Site visit and public consultation: Bronson Pulp Mill ruins public access and Richmond Landing shoreline access

Consultation Report

Table 2

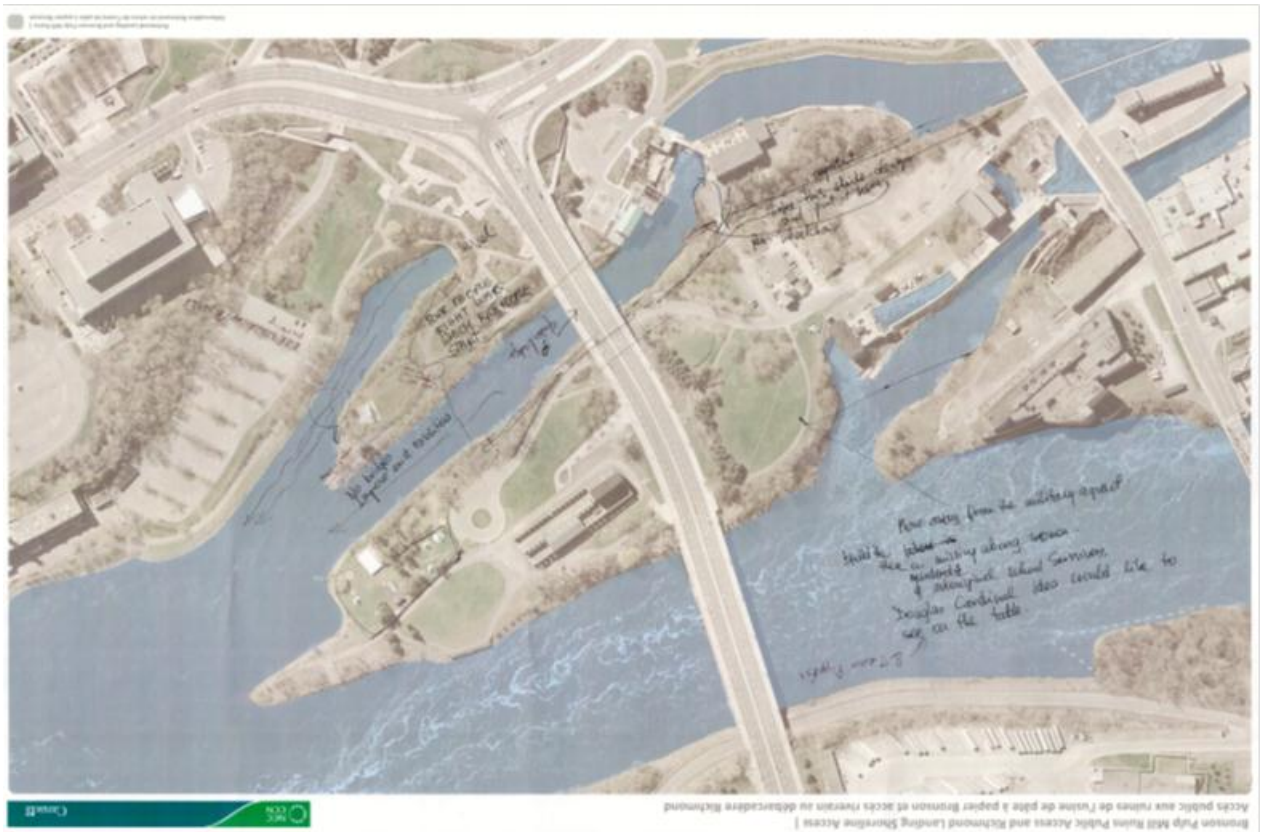
- The first priority should be universal accessibility, on the land and on water.
- The American eel should be protected.
- Existing structures should be used as much as possible.
- Bridge design should be similar to architecture found in the area.

Table 3

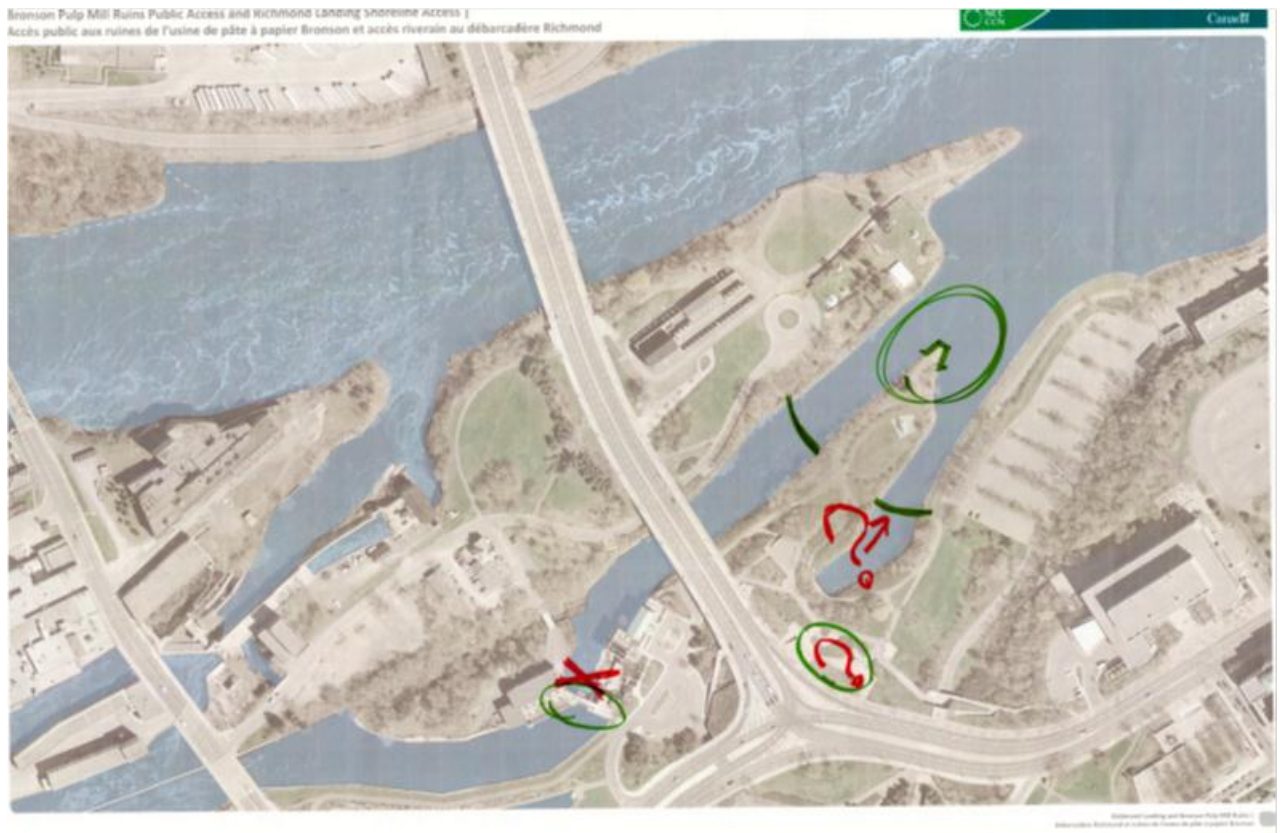
- Install benches and interpretive panels along the new pathways.
- Use indigenous plants for landscaping.
- Preserve the views, and use existing infrastructure.
- Involve Douglas Cardinal.
- Have peace and reconciliation as an interpretive theme.

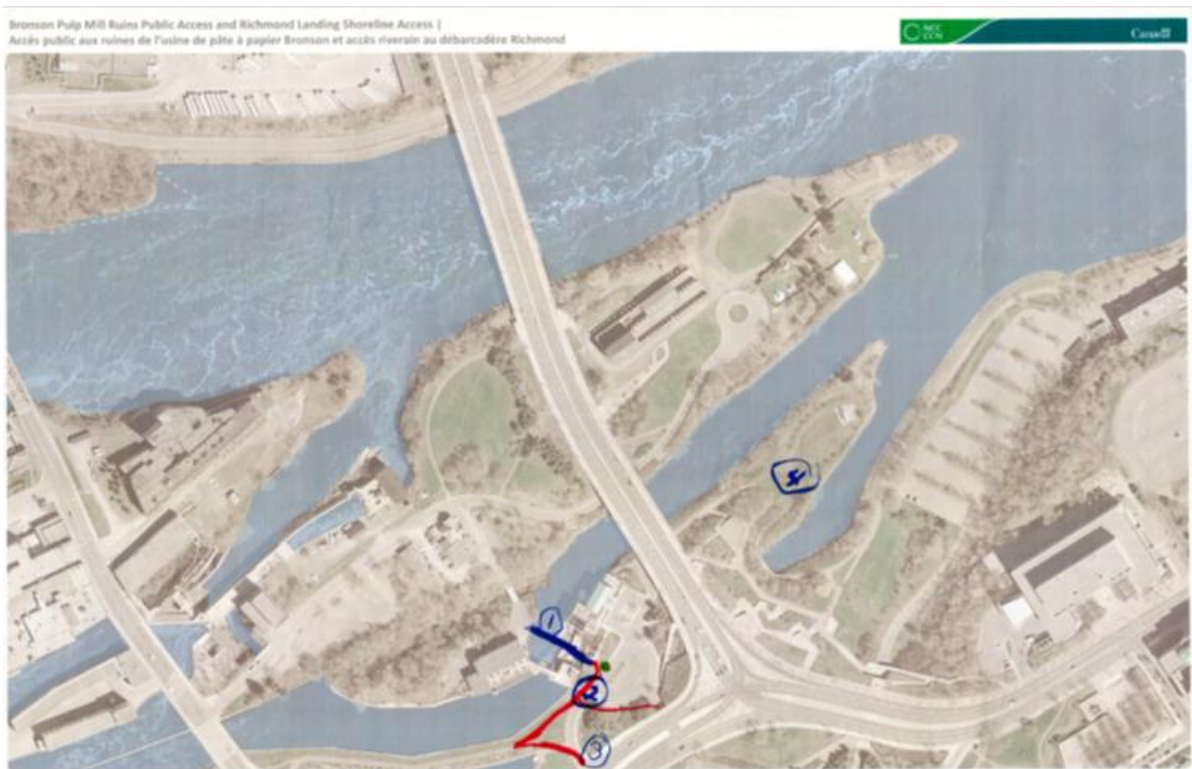
- The bridges provide opportunities to create new views.
- It is important to keep the shorelines as natural as possible.
- When planning for parking needs, reconcile the uses for the restaurant; look at bike routes and bus service.
- Participants agreed with the four interpretive themes (Aboriginal, natural, industrial and military).
- Think of security when designing lighting for the area.
- Have space for public art.
- Share parking with the restaurant.
